CAMDEN COUNTY PLANNING BOARD
CHARLES J. DEPALMA COMPLEX
2311 EGG HARBOR ROAD
LINDENWOLD, NJ 08021

July 26th, 2022

**CAMDEN COUNTY PLANNING BOARD
COUNTY ENGINEER'S REVIEW
OF SUBDIVISIONS AND
SITE DEVELOPMENT PLANS**

**COUNTY PLAN:
SP-6-3-22**

STAFF REPORT MEETING OF:	RE:	Pine Hill Tavern
	Plan:	SP-28-1-22
	Municipality:	Pine Hill
	Applicant:	Danelle Errig
	Abuts County Route:	Erail Rd. Cr 703

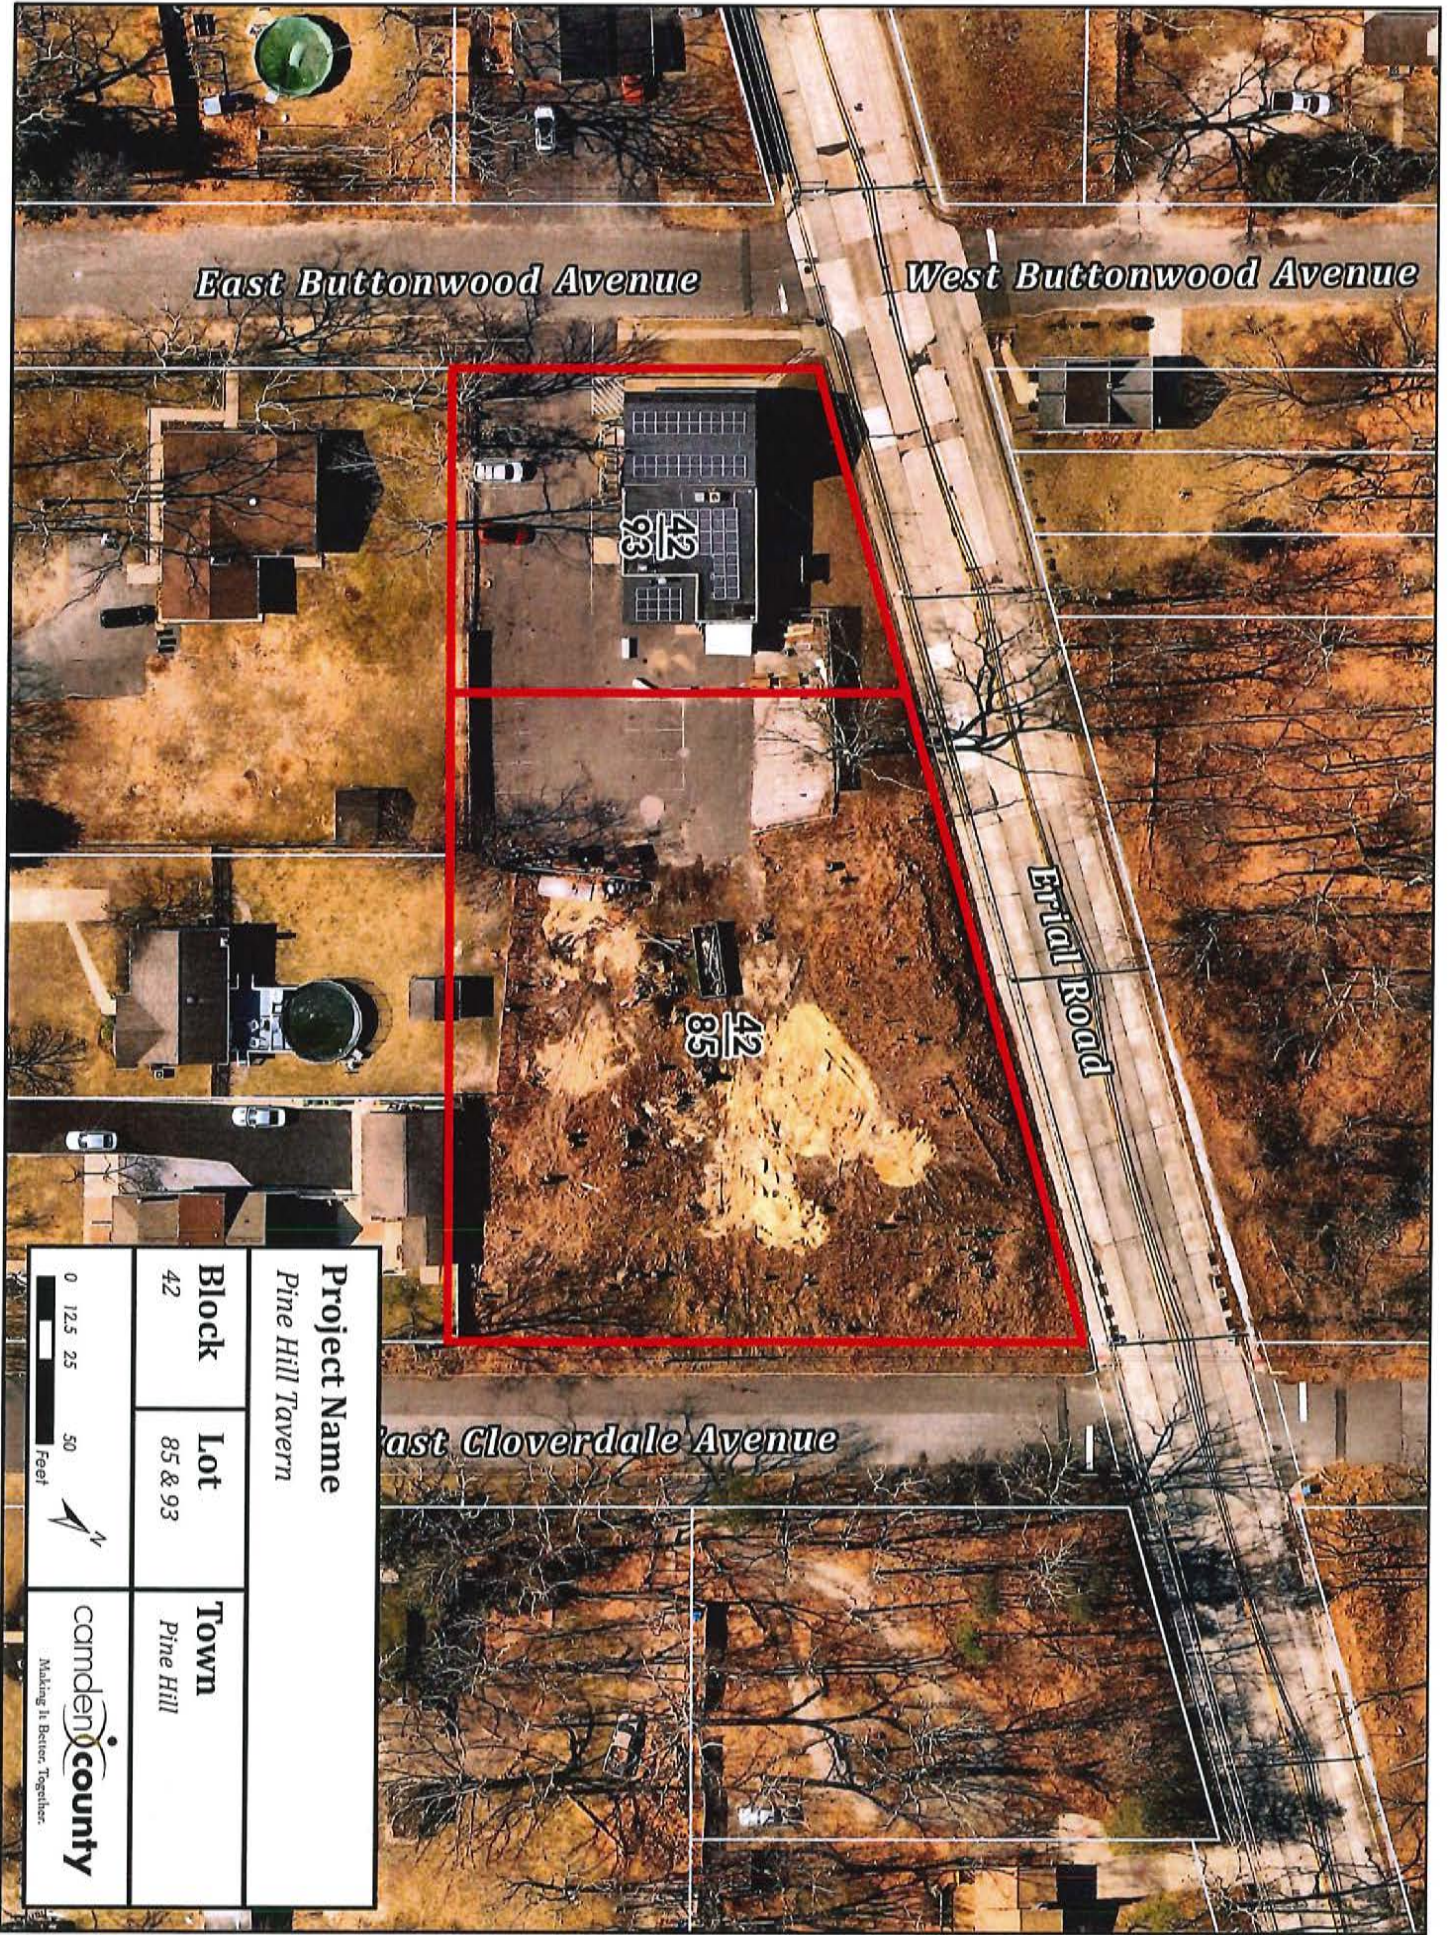
The subject of our review is focuses on stormwater as a result of the paved parking lot and proposed basin.
